**AMENDMENT to  
Public Authority Application to Federal Railroad Administration  
(Ref: THR 000000440001)  
Whatcom County, Washington-  
Yacht Club Rd., DOT #084796F M.P. 89.37 Quiet Zone**

### **III. Whatcom County Requested Revision**

YACHT CLUB RAILWAY CROSSING  
COUNTY ROAD-RAILROAD GRADE CROSSING IMPROVEMENT  
MOUNTABLE RAISED CURB MEDIAN EXHIBIT

DETAIL OF REVISED SECTION OF CONCRETE CURB MEDIAN  
NOT TO SCALE

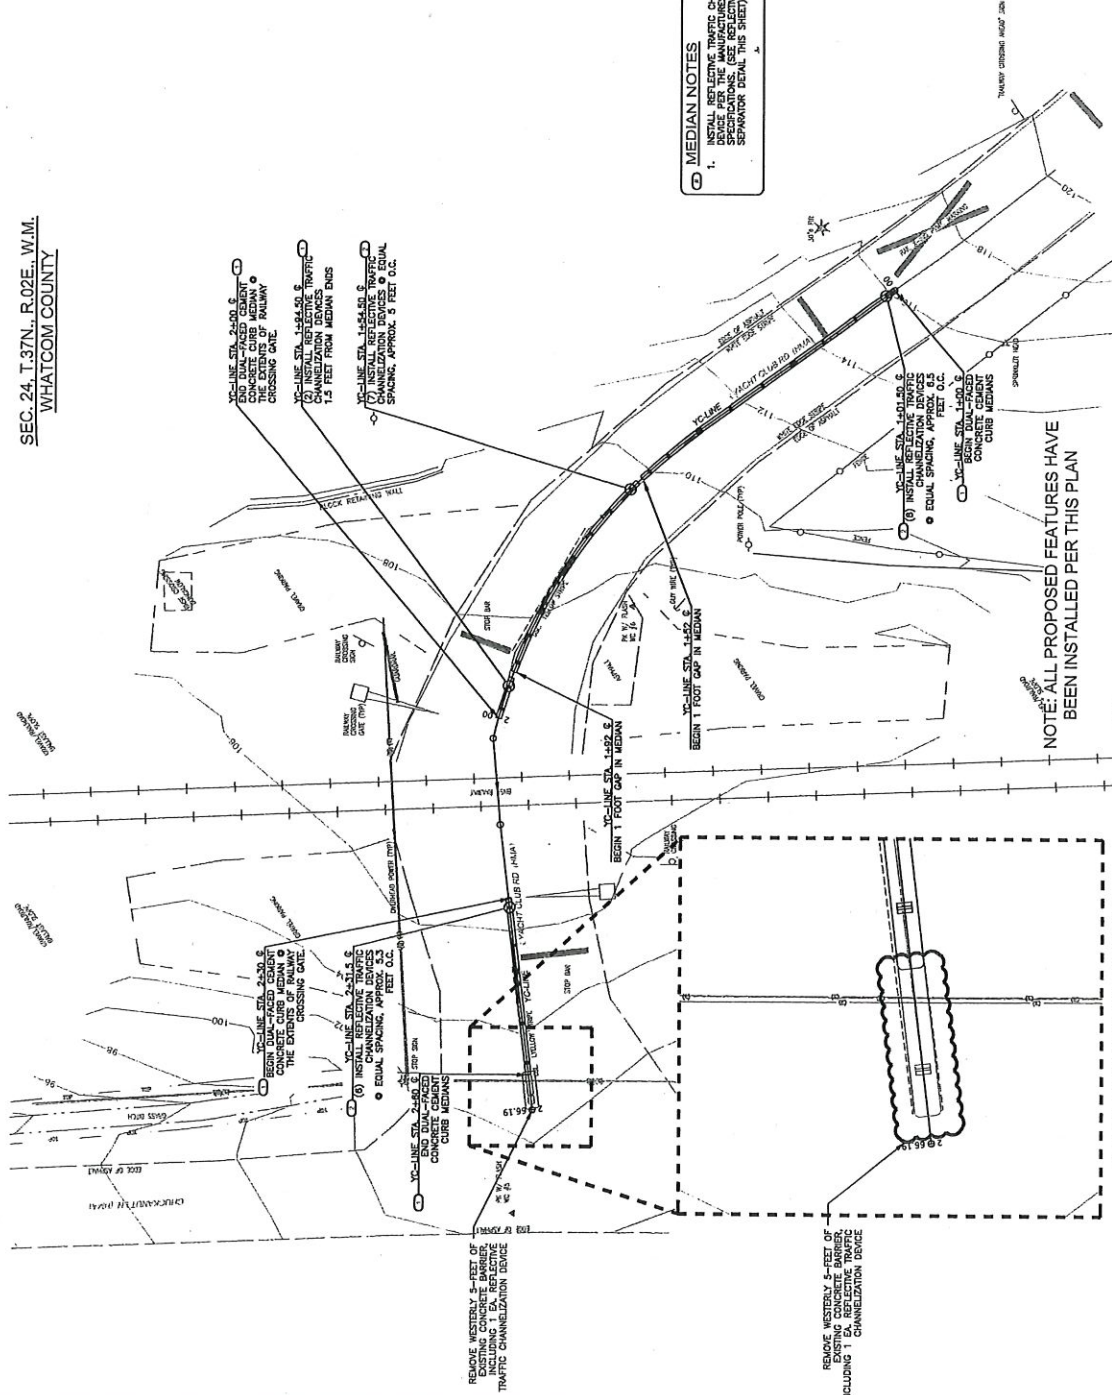
The upgrades to the centerline medians from mountable to non-mountable have inhibited the left hand turn movements of trash/recycling trucks and fire apparatus that would have not been a factor in the original design for mountable medians. The County has improved the shoulders to assist the trucks with this movement. The trucks are still making the turn but need to utilize the improved shoulder and rolling over the last few feet, including a reflector, on the westerly 5 foot portion of the non-mountable median.

The County realizes that this will become a major maintenance effort to maintain the median, the reflector, and the gravel shoulder. This is constant rolling over of a 6-inch will also increase the wear on the trash/recycling trucks. The County would like to remove 5-feet from the westerly portion of the westerly non-mountable median, thus reducing the length from 35-feet to 30-feet.

REMOVE WESTERLY 5'-FEET OF EXISTING CONCRETE BARRIER INCLUDING 1 EA. REFLECTIVE TRAFFIC CHANNELIZATION DEVICE
